TF15-002

ITB15-014

March 17, 2015

## 2013 JX35 AND 2014 QX60 AWD ERROR DISPLAYED AND DTC C1204 STORED

Figure 2

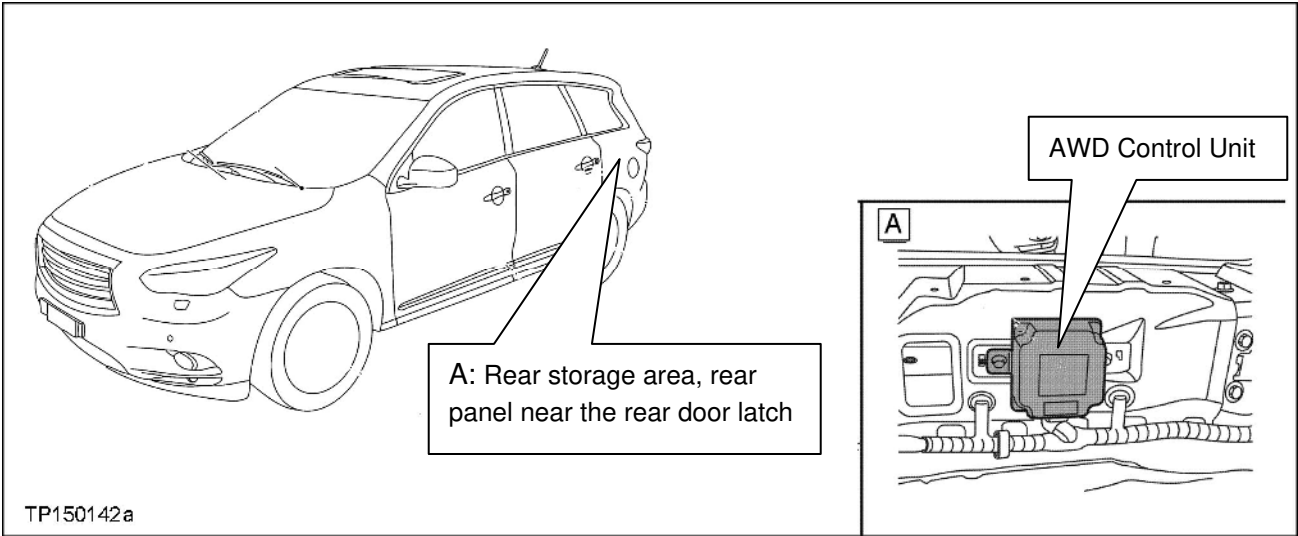
Replace the AWD Control Unit with the one listed in the Parts Information below (see Figure 2).

- Refer to the Electronic Service Manual (ESM), section DLN-Driveline, for replacement information.
